③② P/N: 544-3733

DESCRIPTION		D-SUB WITH 9-PIN MALE CONNECTOR BY MACHINING						
製圖	DRAWN	TOLERANCE	品名	050-0009P-M	DATE	版次	REV.	
	Yoko							.X ±0.2
檢圖	CHECK	.XX ±0.1	單位	mm(in)	DWG.NO.	55-0043	SCALE	
	Ivan							比例
認定	APPROVAL	.XXX ±0.05	ANGLE	±5°				
	Angela

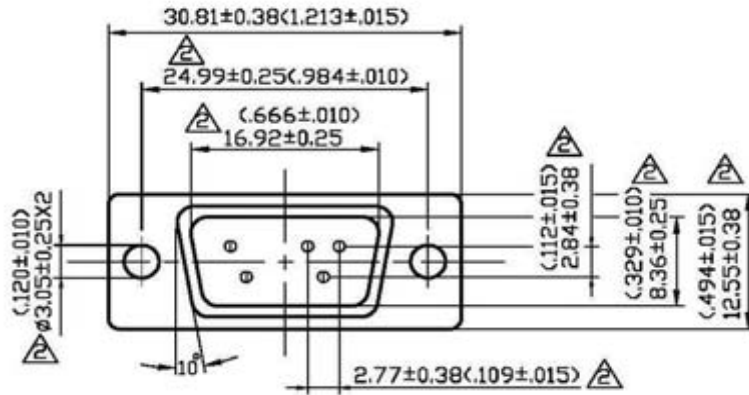
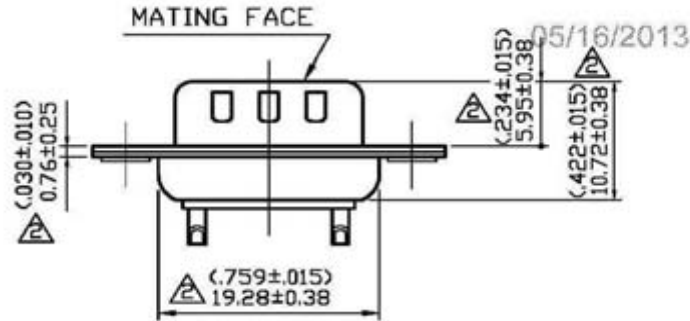
NO	DESCRIPTION	DATE
①	ADD MIS PART NO.	04.01.04
②	ADD DESCRIPTION 24.99±0.13 → 24.99±0.25 16.92±0.13 → 16.92±0.25 ∅3.05 → ∅3.05±0.25 8.36 → 8.36±0.25 12.55 REF. → 12.55±0.38 2.77 → 2.77±0.38 19.28 REF. → 19.28±0.38 1 → 0.76±0.25 (5.97) → 5.95±0.38 10.72 REF. → 10.72±0.38 11 REF. → 10.72±0.38 3.3 REF. → 2.7±0.5 2.84 → 2.84±0.38 TIN → GOLD MIS PART NO. → P/N	10.02.07
③	GOLD	05.16.13
